Report / Decision on a Non-notified Subdivision Consent Application

Application Number: RMA/2022/3963
Applicant: Suburban Estates Limited
Site address: 102a Birkdale Drive and 148 Lake Terrace Road
Site area: 340m² and 9.4372ha
Legal Description: Lots 2 and 3 DP 24511
Zone:
District Plan: Open Space Community Parks Zone, Open Space Metropolitan Facilities
Proposed Plan Change 14: Open Space Community Parks Zone , Open Space Metropolitan Facilities

Description of Application: 15 Lot fee simple subdivision with two road allotments and three Local Purpose reserves to vest, and associated bulk earthworks.

Corrections under s133A

SHEET TITLE :
Proposed Subdivision of
Lot 8 DP 307132 &
Lot 67 DP 335396

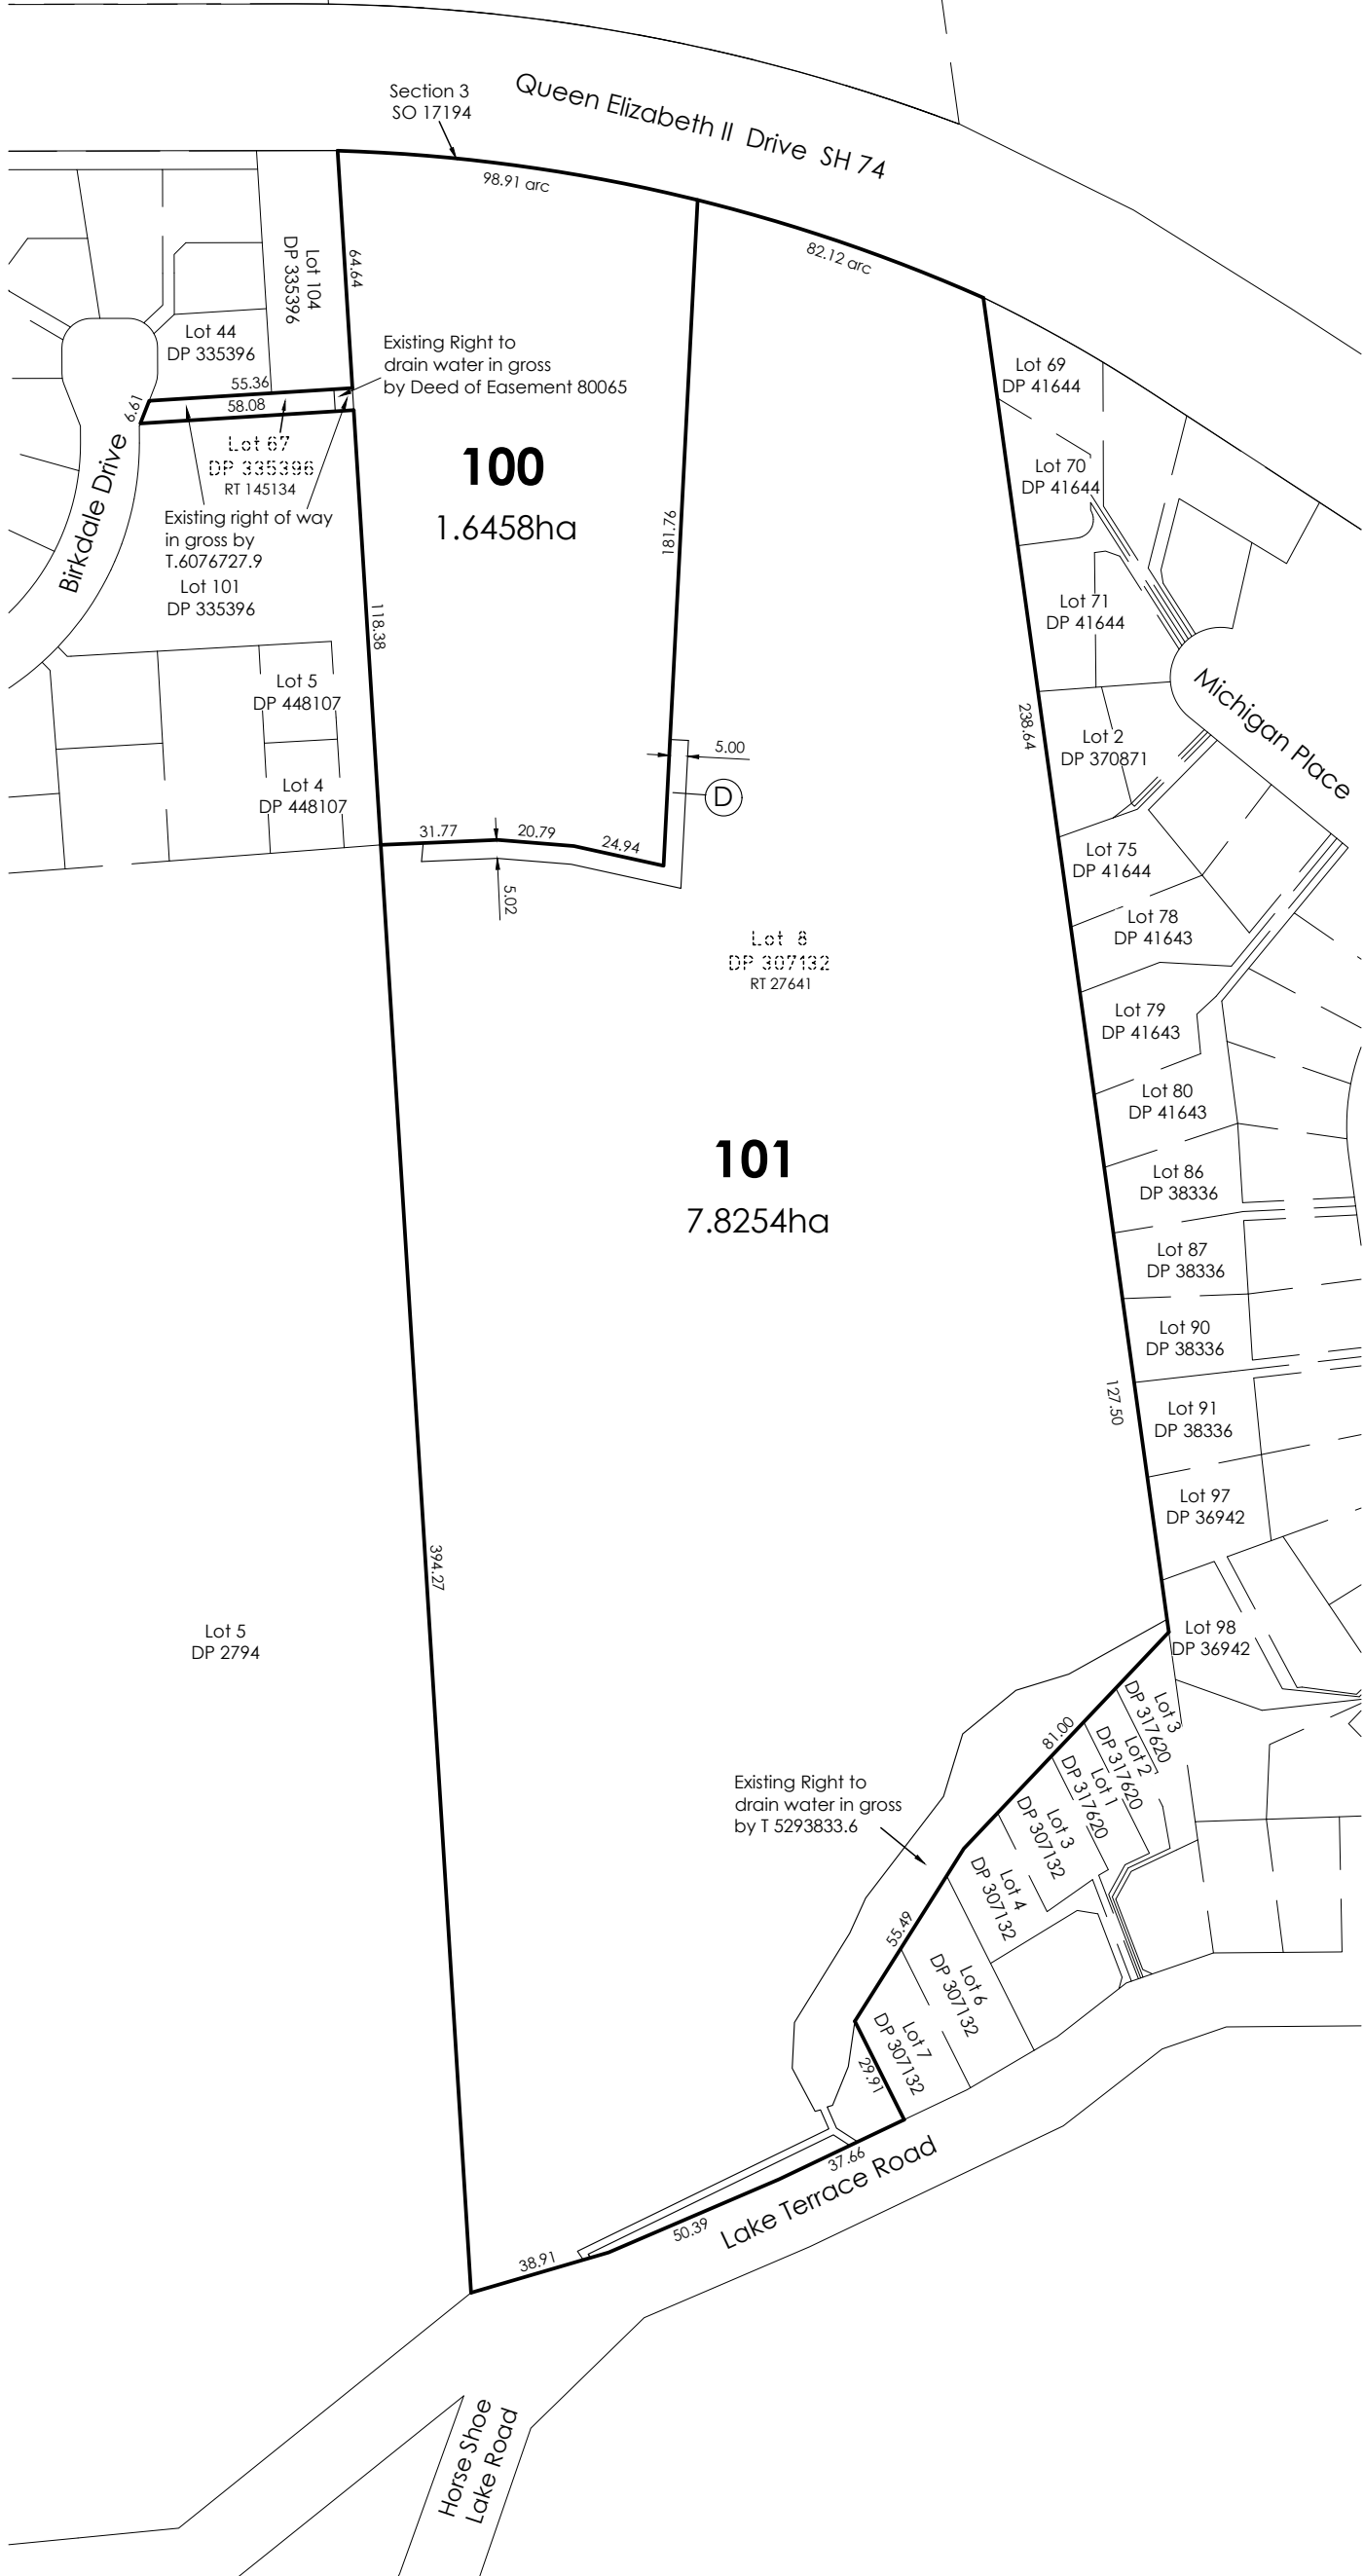
- Condition 1.3
Lot 27 is not a Local Purpose Reserve. As previously advised it is for a power kiosk and will be owned by Orion. It needs to be removed from this condition.
- Condition 6.18 and 17.3
Whilst agreed to in draft conditions. The consent holder seeks clearer reference to Area D on the consent/survey plan. This area is being surveyed and will appear on the survey/title plan. The conditions/consent notice to read: No structures or building are to be constructed within Area D as shown on the consent plan.
- Conditions 15.1 and 15.4
The consent holder considers the height of the bund (1.5m), as reflected in condition 17.4 should be stated in 15.1 and 15.4.

- 6.18 ~~Future structures / dwellings on Lot 101 shall be setback a minimum of 5m from the boundary of Lot 23.~~ **No structures or building are to be constructed within Area D as shown on the consent plan.**

AMENDMENT	DATE	DESCRIPTION
R1	21.03	CONSENT NOTICE AREA ADDED
